SUBJECT:
Compressor 9181137-01's
Overload 9181005-45

Number: 2022-07
Product: Compressor Overload
Date Issued: July 2022
From: Technical Services

Figure 3: Current 9181005-45 on the left, previous design on the right

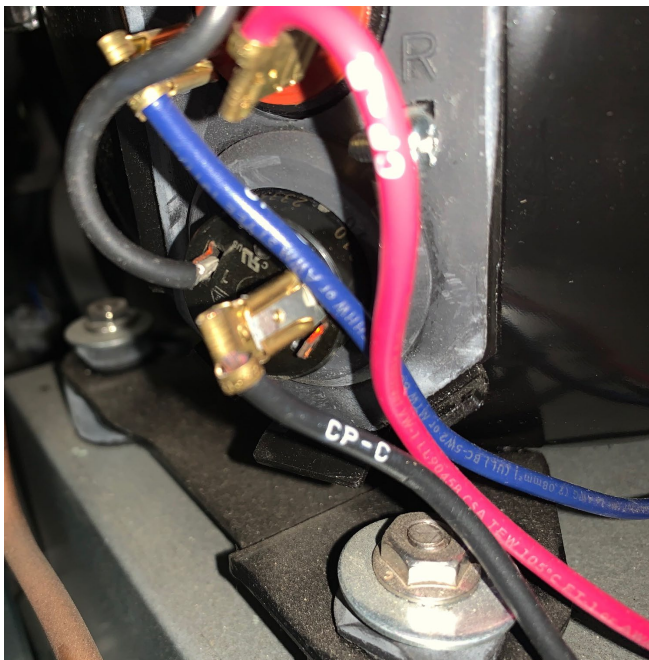
Ice-O-Matic's supplier of the 918005-45 compressor overload (used in older versions of the 9181137-01 compressor) added an alternate manufacturer for the overload in 2019. This alternate manufacturer is now the only provider of the part, and it has a larger outer diameter that makes for a tighter fit into the mounting grommet on the compressor. While this may cause more difficulty during installation, it does fit. The current version of the 9181005-45 is the compressor manufacturer's preferred replacement.
